**RE: PROGRESS ON INFORMATION CONCERNING WATER LICENCE RENEWAL  
FOR THE HAMLET OF TUKTOYAKTUK (N7L3-0714:**

# ***Hamlet of Tuktoyaktuk Water Licence Renewal Background Report***

## MUNICIPAL WATER USE INSPECTION FORM

Figure 12. Waste Disposal. SWDF waste oil and hazardous wastes area.

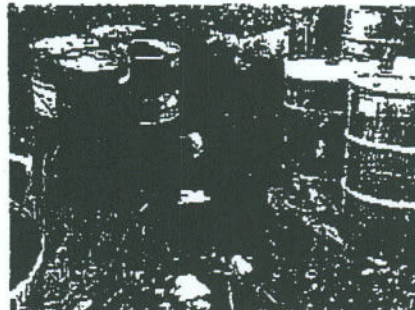
- As indicated last year the SWDF waste oil and hazardous materials area (Figure 12, 13) are becoming permanent storage areas. It is recommended that every effort be made to dispose of these materials at a certified disposal facility. Long term/permanent storage of this material is not recommended. It is only a matter of time before spills occur. It is understood that there is a plan to dispose of this material (waste oil) at Grubens.
